SERVICE BULLETIN

CAB-33-02

LIGHTS - LED NAVIGATION AND ANTI-COLLISION LIGHT ASSEMBLIES INSTALLATION

This service document provides parts and instructions necessary to replace the incandescent navigation and anti-collision light assemblies with LED light assemblies.

Figure 1. Group A Airplanes Wiring Modification (Sheet 1)

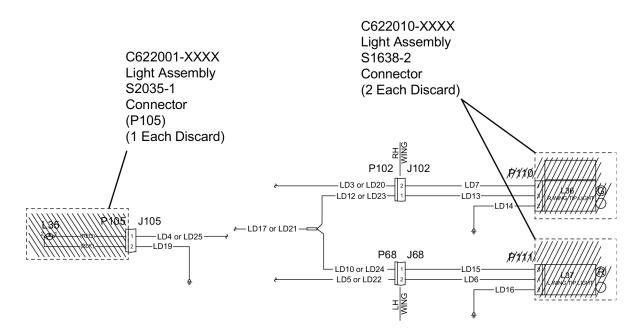
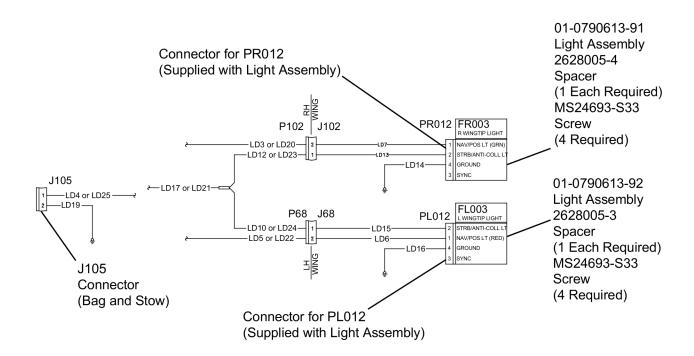
- 7. **Group A Airplanes:** (Refer to Figure 1, Sheet 1, and Sheet 2.) Complete the wing tip wiring modification as follows:
 - A. (Refer to Figure 1, Sheet 1.) Depin the wires from the S1638-2 Connectors and discard connectors P110 (Right) and P111 (Left).

- B. Connect the wires that were depined to the new connectors supplied with the new NAV/Anti-Collision light assemblies.
 - C. Install one S4111-2A Namplate marked PL012 on the wire assembly for the left Nav/Anti-Collision light assembly with two MS3367-1-9 Tie Straps.

- D. Install one S4111-2A Namplate marked PR012 on the wire assembly for the right Nav/Anti-Collision light assembly with two MS3367-1-9 Tie Straps.
 - E. Go to Step 11.

Figure 2. Group B Airplanes Wiring Modification (Sheet 1)

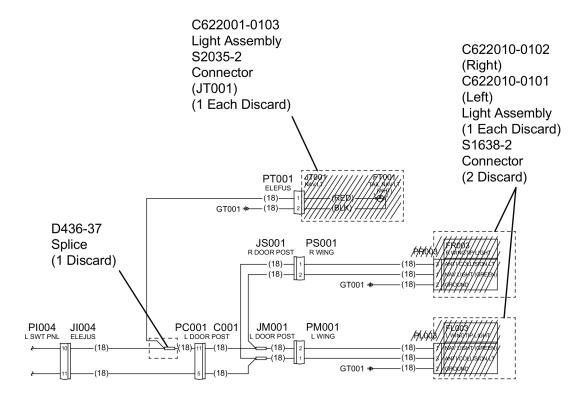
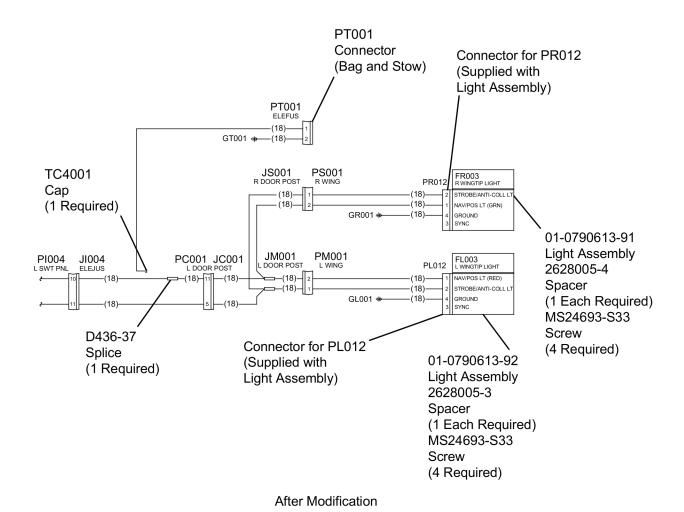
- 8. **Group B Airplanes:** (Refer to Figure 2, Sheet 1, and Sheet 2.) Complete the wing tip wiring modification as follows:
 - A. (Refer to Figure 2, Sheet 1.) Depin the wires from the S1638-2 Connectors and discard connectors PR003 (Right) and PL003 (Left).

- B. Connect the wires that were depinned to the new connectors supplied with the new NAV/Anti-Collision light assemblies.
 - C. Install one S4111-2A Namplate marked PL012 on the wire assembly for the left Nav/Anti-Collision light assembly with two MS3367-1-9 Tie Straps.

- D. Install one S4111-2A Namplate marked PR012 on the wire assembly for the right Nav/Anti-Collision light assembly with two MS3367-1-9 Tie Straps.
 - E. Go to Step 10.

- A. Remove the left front side panel located forward of the pilot-side circuit breaker panel.
 - B. (Refer to Figure 2 and Figure 3, Sheets 1.) Locate and remove the D436-37 Splice and wire identified as 1PT001 from connector PC001 Pin 11 (wire 11PC001-10JI004).

- **NOTE:** Wire 1PT001 is the power wire for the tail navigation light. Wire 11PC001-10JI004 will be spliced together without wire 1PT001.
 - C. (Refer to Figure 2 and Figure 3, Sheets 2.) Install a TC4001 Cap on the end of 1PT001 Wire.

- D. (Refer to Figure 2 and Figure 3, Sheets 2.) Connect 10JI004 to 11PC001 Wires with one D436-37 Splice.
 - E. Install the left front side panel located forward of the pilot-side circuit breaker panel.

Figure 3. Group C Airplanes Wiring Modification (Sheet 1)

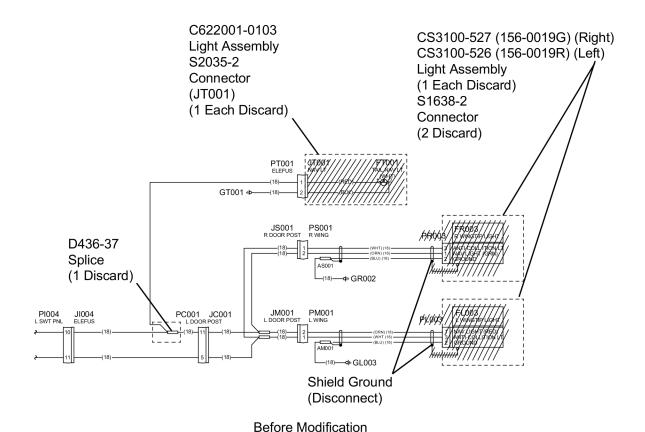
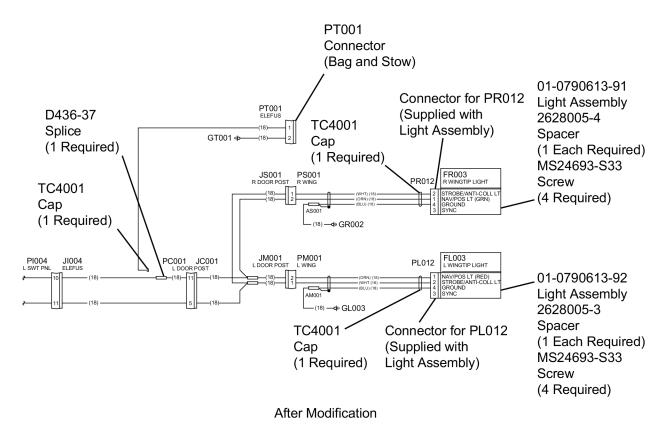
- 9. **Group C Airplanes:** (Refer to Figure 3, Sheet 1, and Sheet 2.) Complete the wing tip wiring modification as follows:
 - A. (Refer to Figure 3, Sheet 1.) Depin the wires from the S1638-2 Connectors and discard connectors PR003 (Right) and PL003 (Left).

- B. (Refer to Figure 3, Sheet 1.) Disconnect the shield ground from the depinned wires at PR003 (Right) and PL003 (Left).

- C. (Refer to Figure 3, Sheet 2.) Install a TC4001 Cap on the end of the two disconnected shield grounds.
- D. Connect the wires that were depinned to the new connectors supplied with the new NAV/Anti-Collision light assemblies.

- E. Install one S4111-2A Namplate marked PL012 on the wire assembly for the left Nav/Anti-Collision light assembly with two MS3367-1-9 Tie Straps.
- F. Install one S4111-2A Namplate marked PR012 on the wire assembly for the right Nav/Anti-Collision light assembly with two MS3367-1-9 Tie Straps.
